UNITED STATES PATENT AND TRADEMARK OFFICE

09/990,273

Office Action Summary	Application No. 09/990,273	Applicant(s) HSIAO ET AL.	
	Examiner David S. Kim	Art Unit 2633

DETAILED ACTION**Specification**

Fig. 3

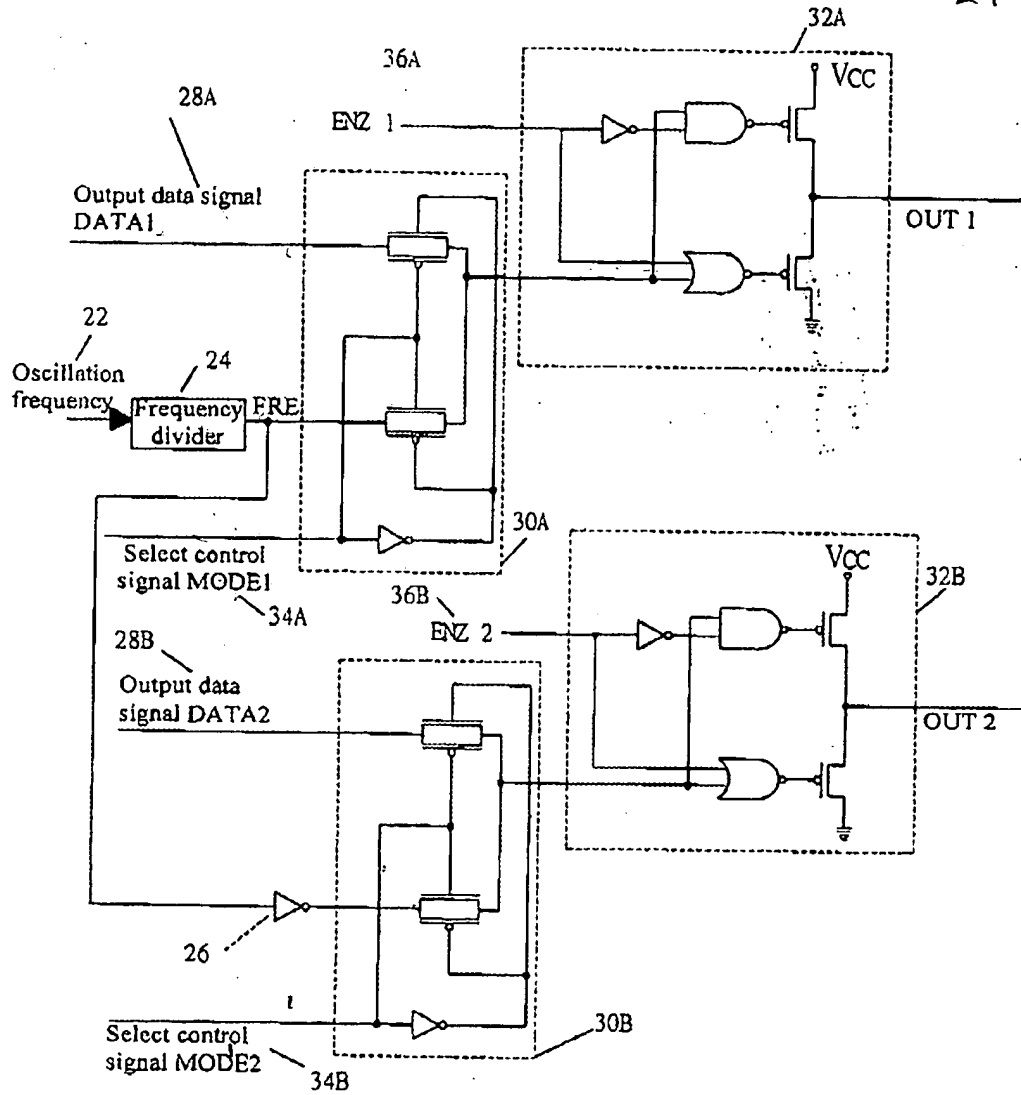
Approved by DSK
 27 September
 2005

Fig. 5

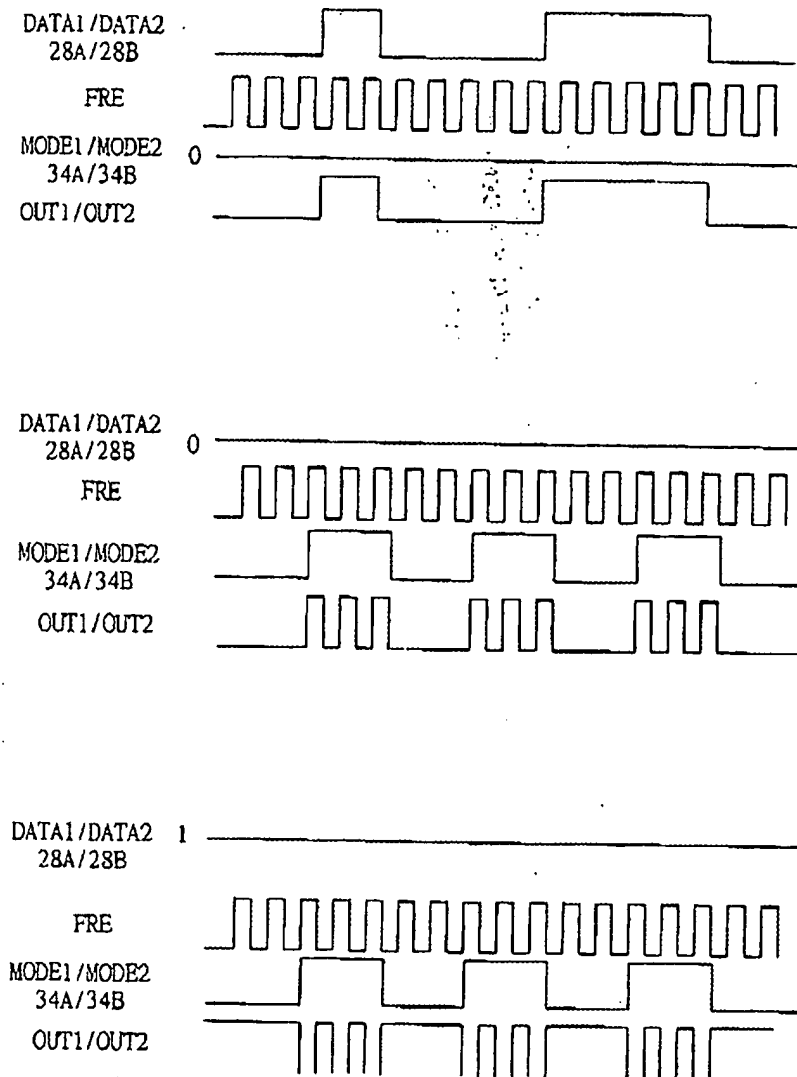
2. The replacement drawings were received on 12 May 2005. Fig. 3 is approved. However, Fig. 5 is disapproved. Fig. 5 is objected to because the middle (Fig. 5(B)) and bottom (Fig. 5(C)) diagrams do not appear to accurately reflect the specification's description of the operation of Applicant's invention.

In Fig. 5(B), "OUT1/OUT2" labels a signal output that may correspond *only* to port OUT1. In particular, the first full paragraph on page 7 of the specification teaches the output of "the *inverse* of the carrier FRE." Fig. 5(B) does not show the output of this *inverse* of the carrier FRE. Rather, it appears to simply show the output of the carrier FRE, as described in relation to port OUT1 in the last paragraph of page 6 of the specification.

Similarly, in Fig. 5(C), "OUT1/OUT2" labels a signal output that may correspond *only* to port OUT2. In particular, the last paragraph of page 6 of the specification teaches the output of "a carrier FRE." Fig. 5(C) does not show the output of this carrier FRE. Rather, it appears to show the output of the *inverse* of the carrier FRE, as described in relation to port OUT2 in the first full paragraph of page 7 of the specification.

Disapproved by

3. Corrected drawing sheets in compliance with 37 CFR 1.121(d) are required in reply to the Office action to avoid abandonment of the application. Any amended replacement drawing sheet should include all of the figures appearing on the immediate prior version of the sheet, even if only one figure is being amended. The figure or figure number of an amended drawing should not be labeled as "amended." If a drawing figure is to be canceled, the appropriate figure must be removed from the replacement sheet, and where necessary, the remaining figures must be renumbered and appropriate changes made to the brief description of the several views of the drawings for consistency. Additional replacement sheets may be necessary to show the renumbering of the remaining figures. Each drawing sheet submitted after the
